**ATTACHMENT I**

**Comments from Federal Land Managers and EPA (with responses)**

Description of Environmental Protection Agency (EPA) Comments on Connecticut's Draft  
Regional Haze State Implementation Plan (SIP) and Connecticut Department of Environmental  
Protection (CTDEP) Responses

**Figure 8.11: Annual Sulfur Dioxide (SO<sub>2</sub>) Emissions, by State**

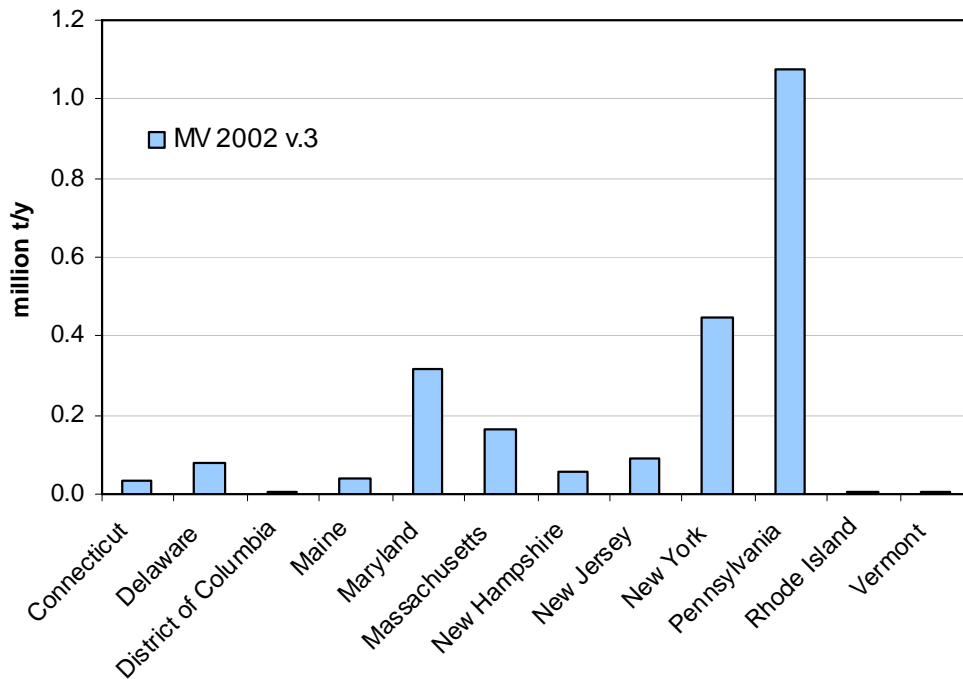
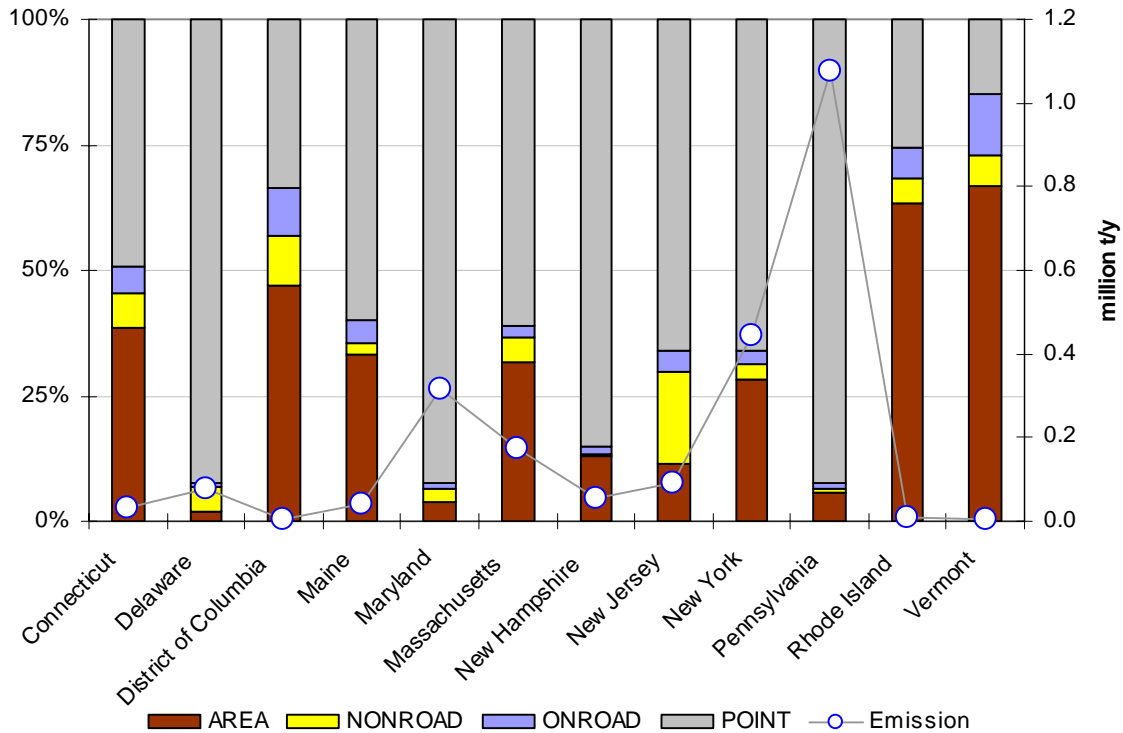
*The reference cited for Figure 8.11 appears inaccurate. Please correct this reference.*

*In the second paragraph of Section 8.3.1, Connecticut states, "Most states in the region showed declines in annual SO<sub>2</sub> emissions through 2002 compared with those previous inventories." Connecticut should include the data that support this statement, refer to another document that contains the supporting data, or remove the statement.*

CTDEP has reorganized and revised the text after the first paragraph in Section 8.3.1, Sulfur Dioxide (SO<sub>2</sub>) as follows:

"Figure 8.11 shows SO<sub>2</sub> emissions in the MANE-VU states as extracted from the 2002 MANE-VU inventory (MARAMA, 2005).

The bar graph in Figure 8.12 displays the percentage contributions from different emission source categories to annual SO<sub>2</sub> emissions in the MANE-VU states in 2002. The chart shows that point sources – consisting mainly of stationary combustion sources for generating electricity, industrial power, and heat – dominate SO<sub>2</sub> emissions in the region.

As can be seen in Table 8.2 (EPA NEI database, 2008), most states in the region showed declines in annual SO<sub>2</sub> emissions through 2002 compared with those from previous inventories.
